Addendum No. 1

Project: Extend Taxiway G and Construct Taxilane K1
FWACAA Project No. AF26-04

Date: June 23, 2026

U8.2.6

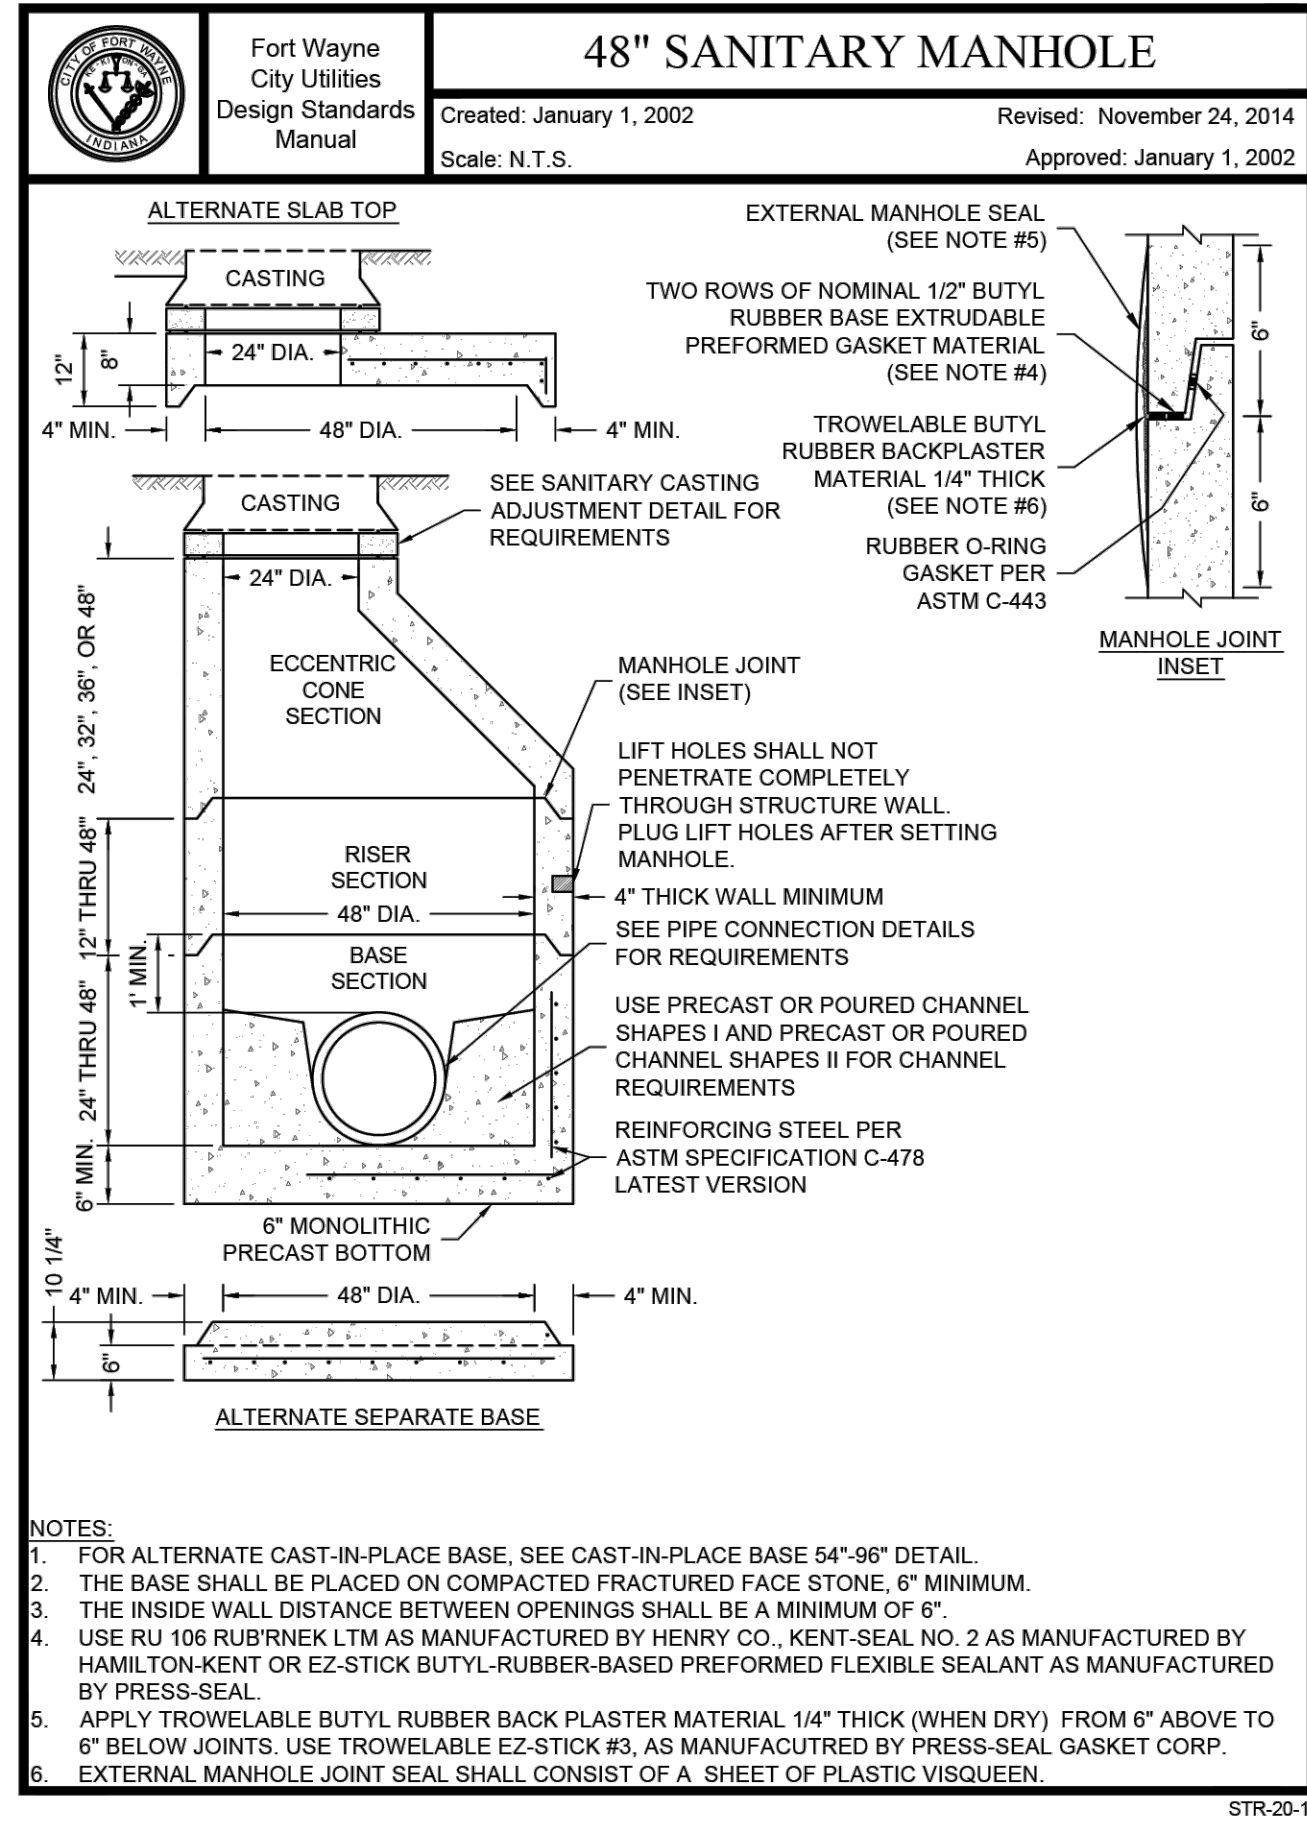
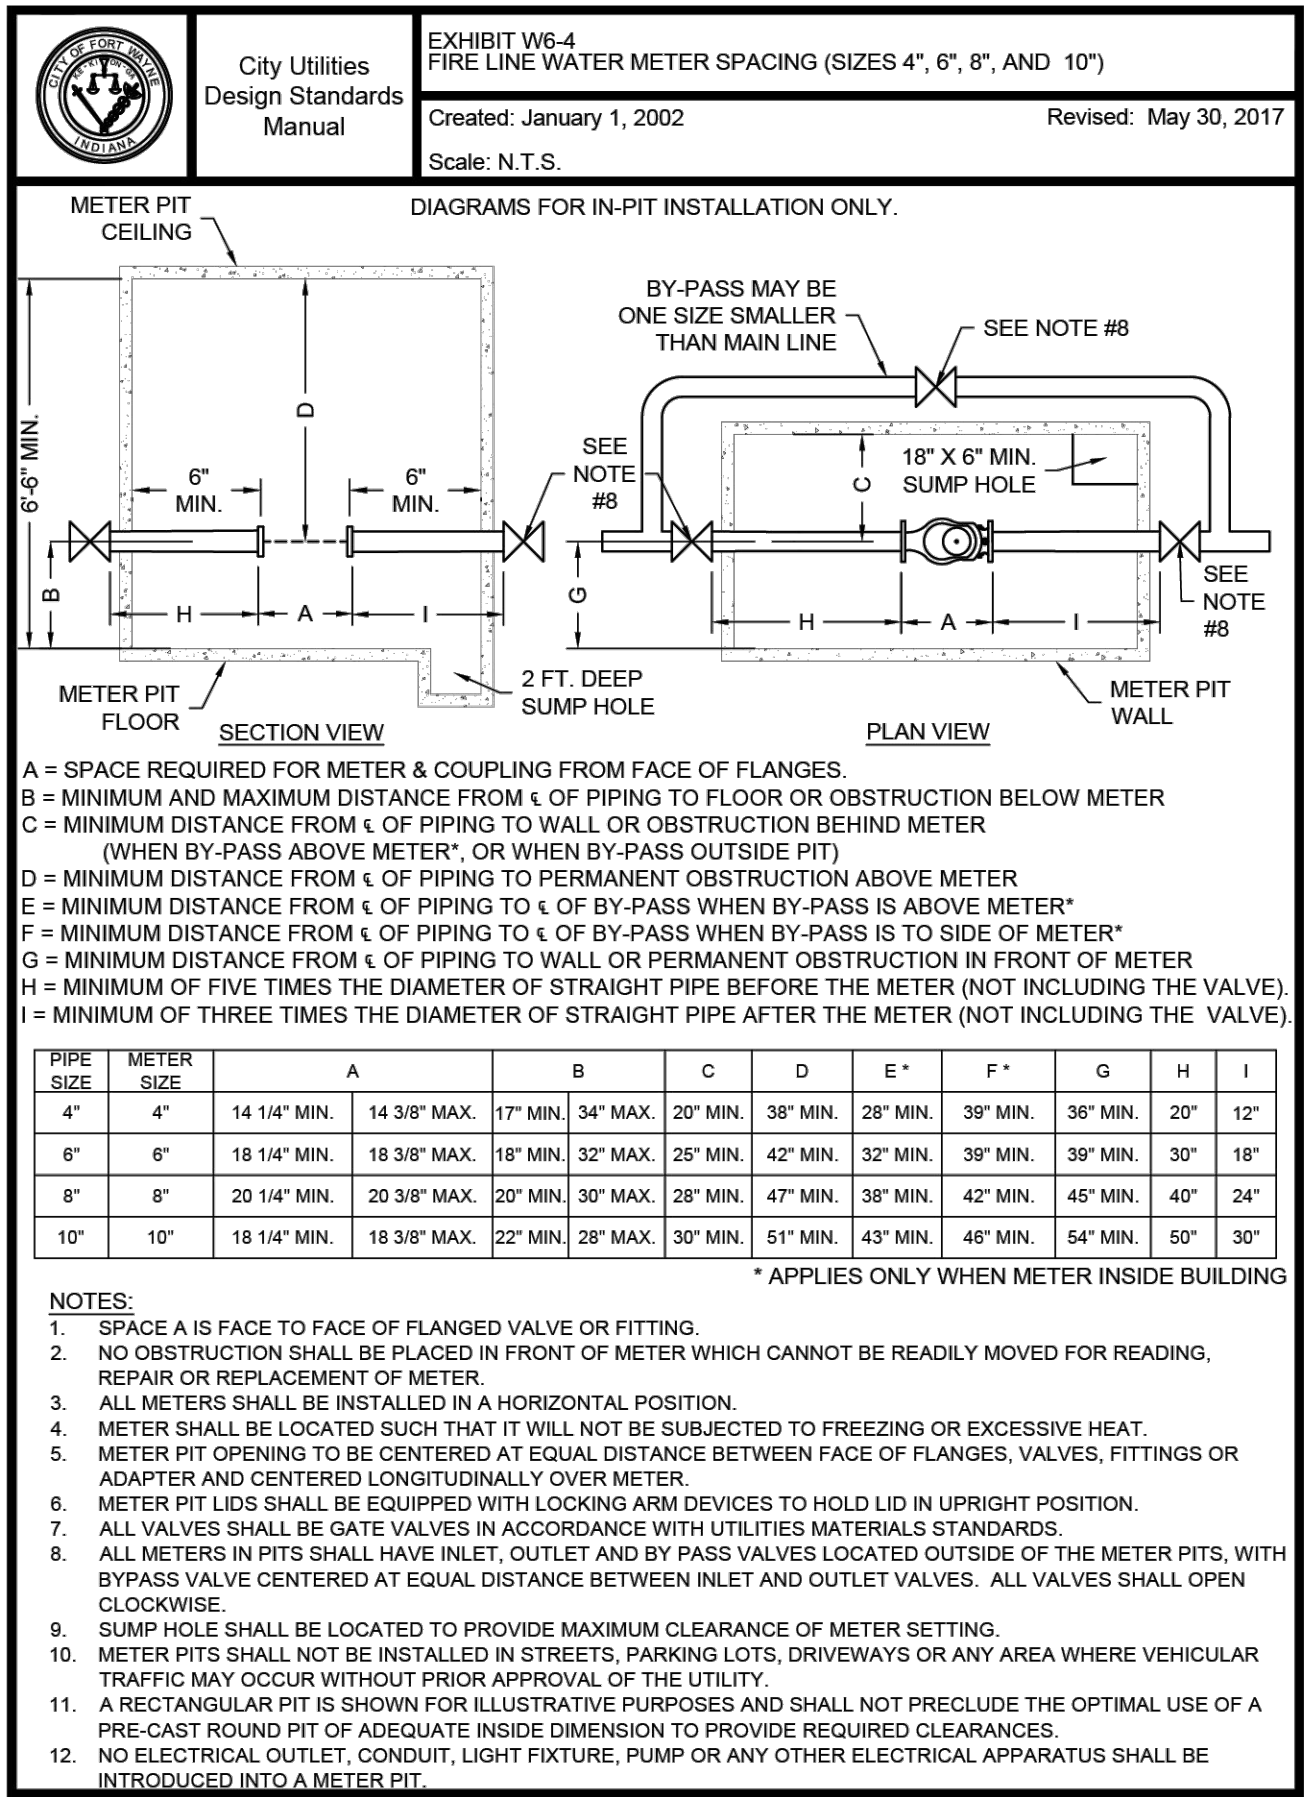
Sheet U8.2.6 – Utility Details

Reissued: Due to various changes this sheet has been reissued in its entirety.
